Access Compliance Report

Public Rights-of-Way

(Pedestrian Signals)

Intersection ID: N/A	Main Street:	Cross Street: N/A	Location: N/A
ADA ID: 0D7507F821B3	Signal Type: Two Push Buttons-Non APS	Overall Compliance: No	Severity Score: BTN 1:N/A BTN 2: N/A No BTN: N/A
Codes/Mitigation Info/Possible Solution		Field Measurements/Component Compliance

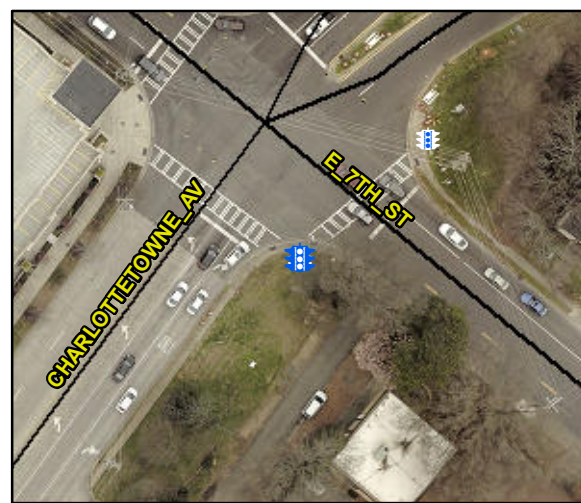
Possible Solutions: Replace Signal Push Button With APS Button on New Post. Remove & Relocate Sign.

PROW/ADA: TMUTCD 4e.08, R404.2, R404.3, R406.2, R404.7.3
